RE: Pawling Commons
Amended Site Plan
63, 67 and 71 East Main Street

Enclosed please find responses to comments included in the 1/04/24 planning review memorandum prepared by Caren LoBrutto of LaBella. Our responses, in boldface, are keyed to the referenced review memorandum.

AMENDED SITE PLAN FOR ALTERNATE EXPANSION

LIGHTING PLAN

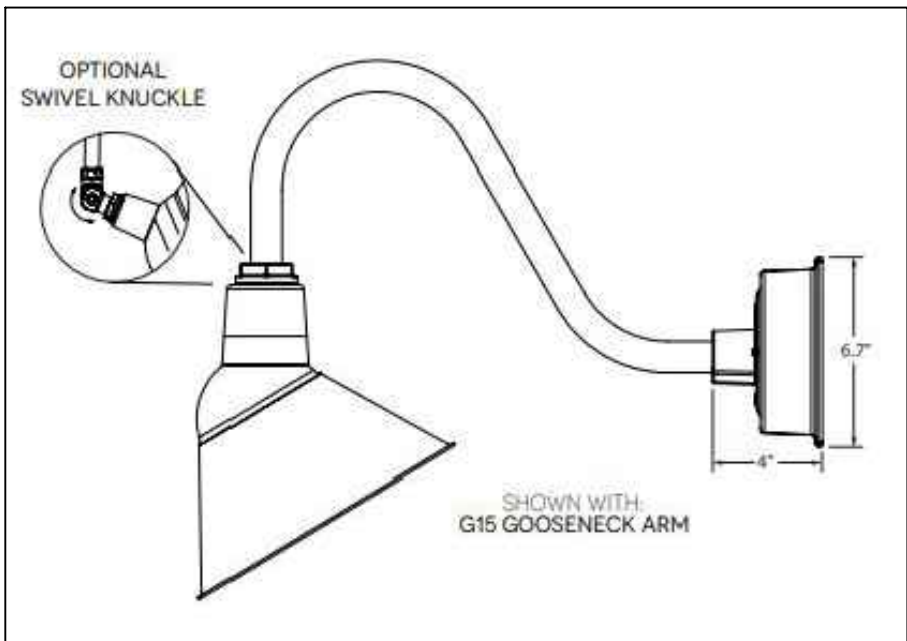
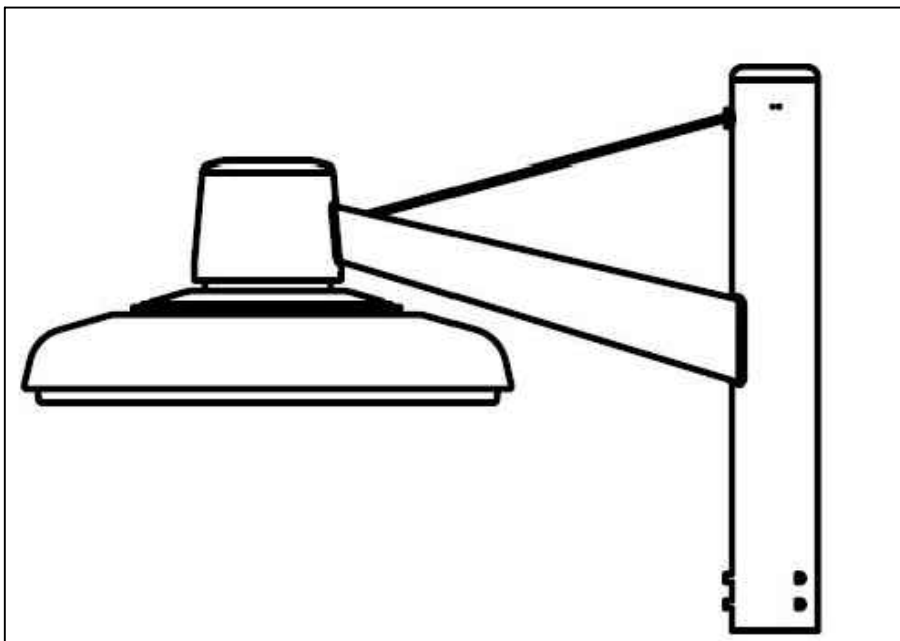
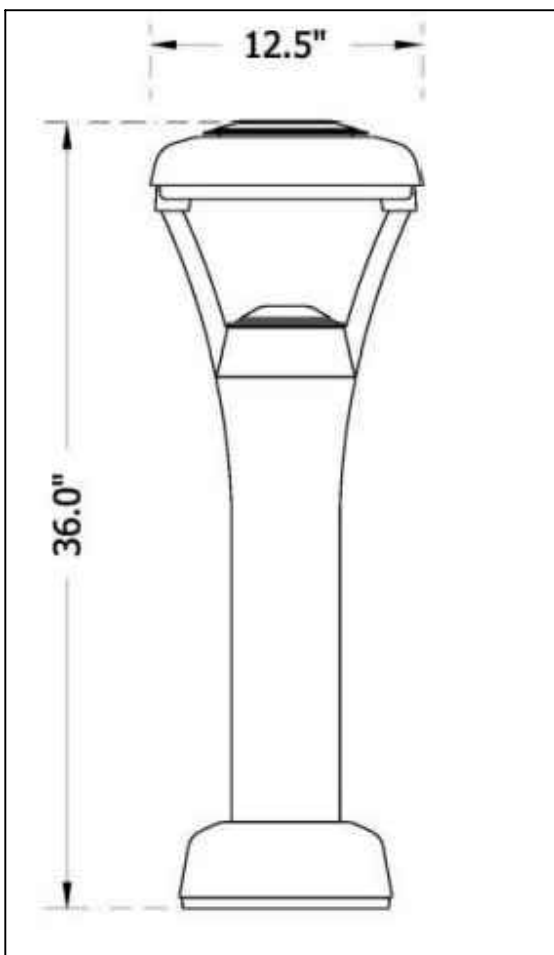
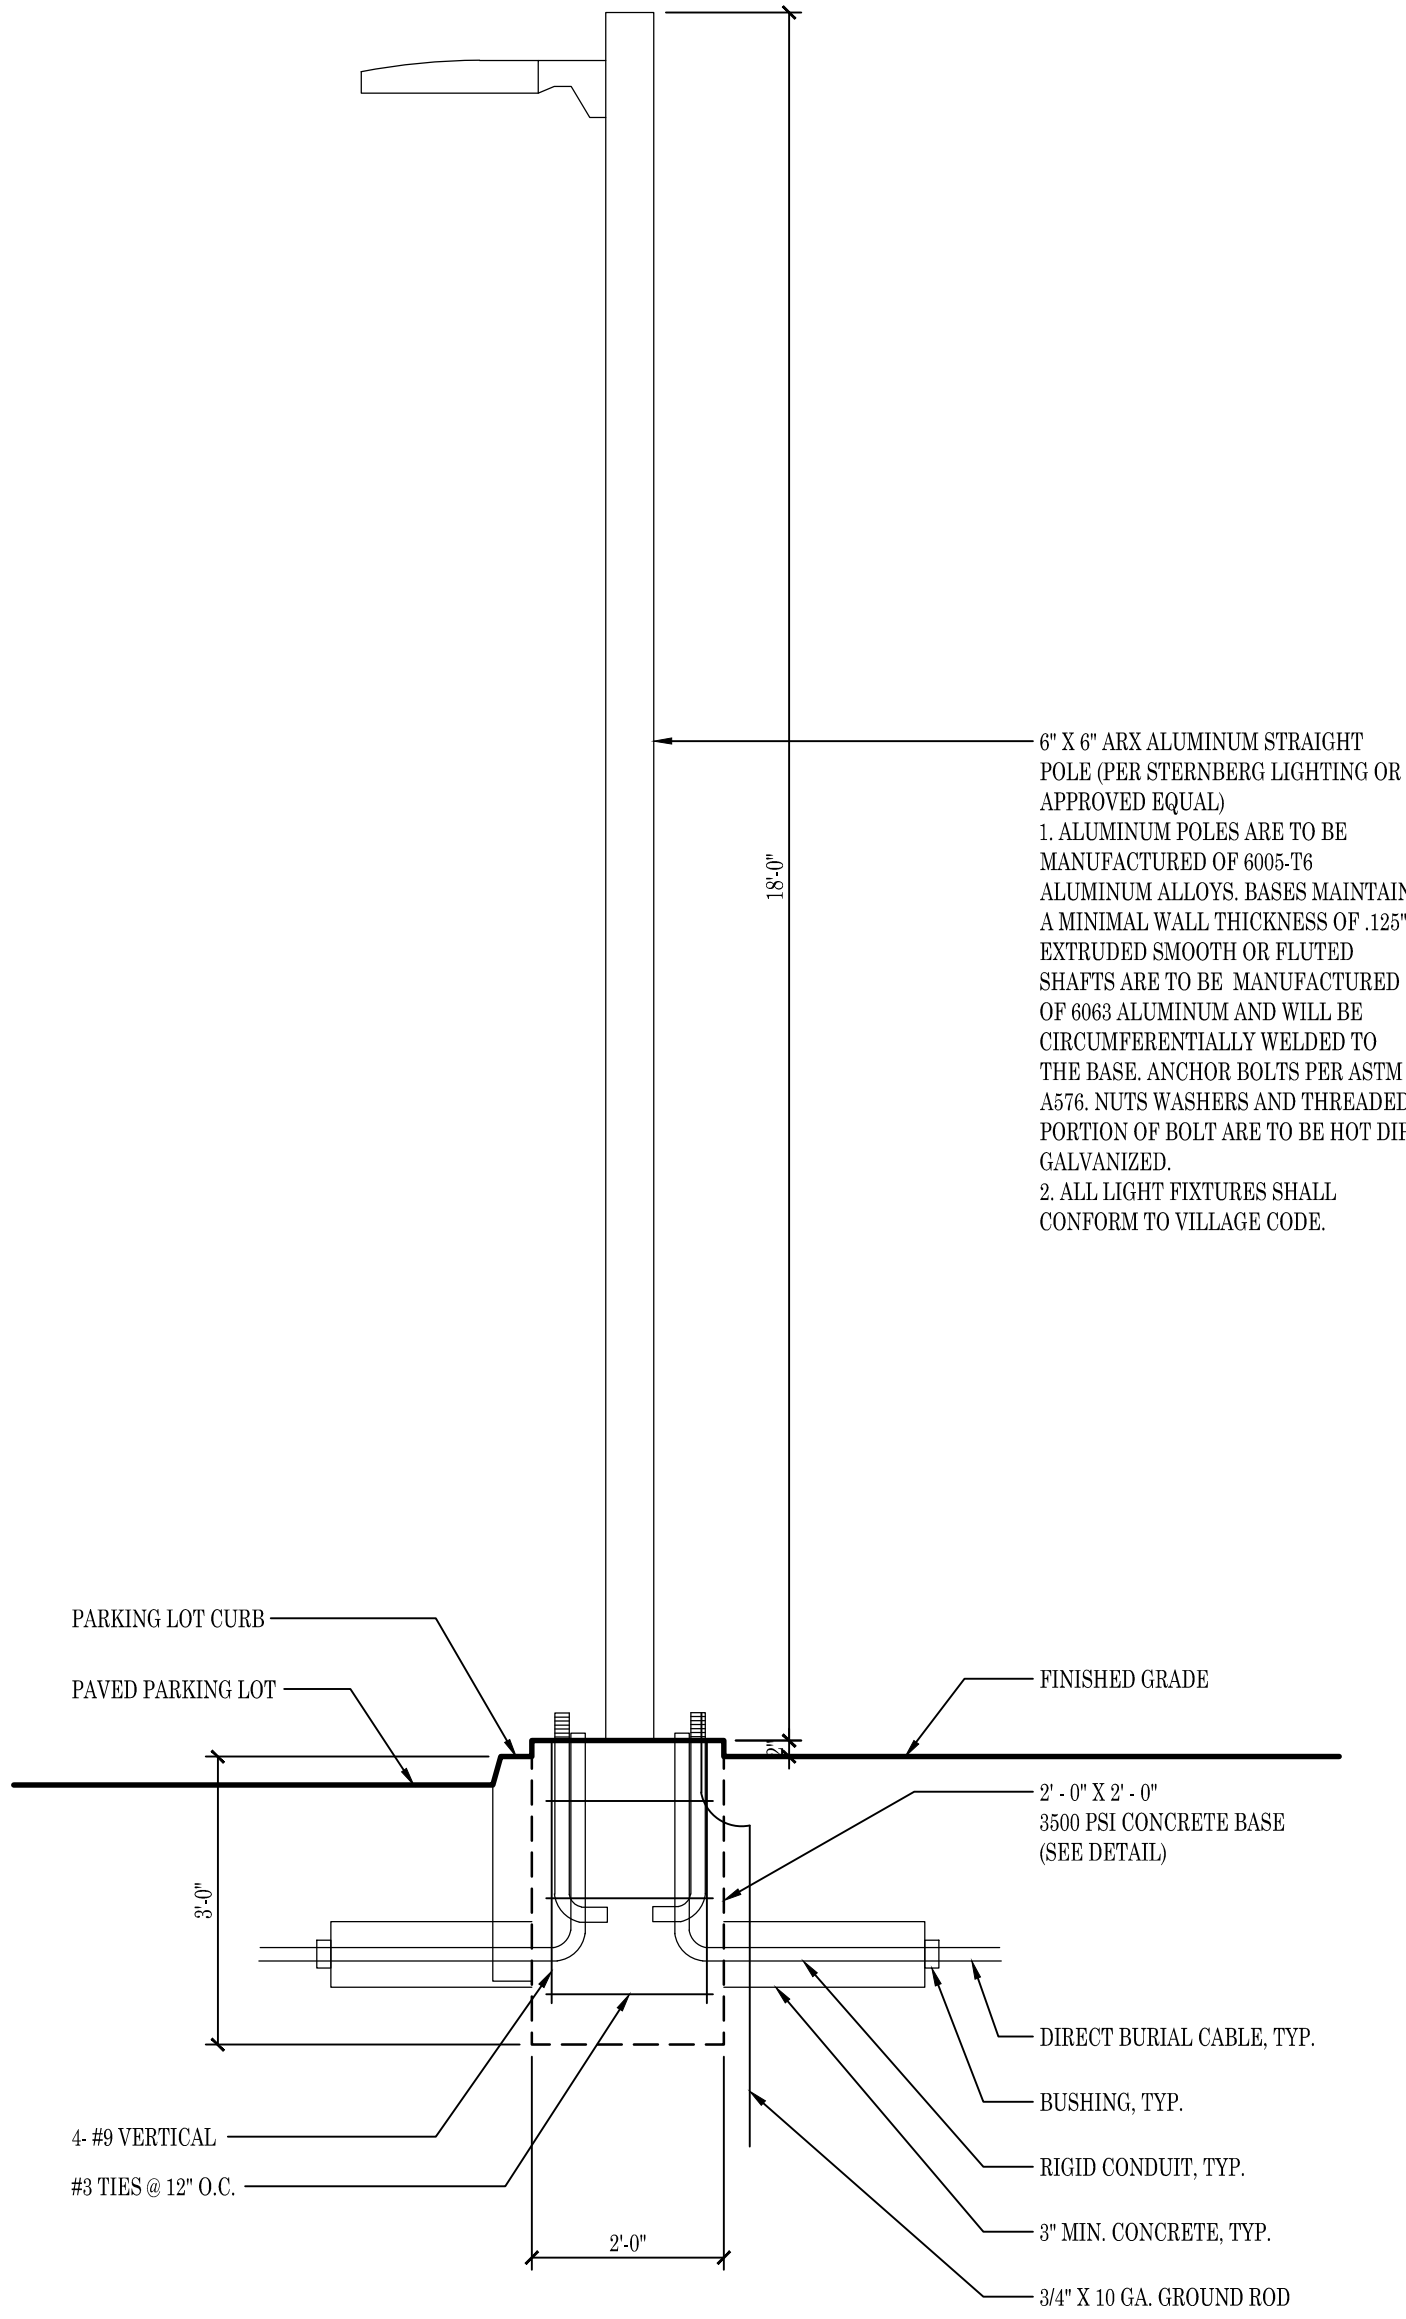
5. Provide additional lighting details related to building-mounted lighting, bollards, etc. Information should include kelvin readings. The photometric plan should show how footcandle levels are spread across the site in addition to the calculation summary.

Response: updated lighting plan has been included in this submission.
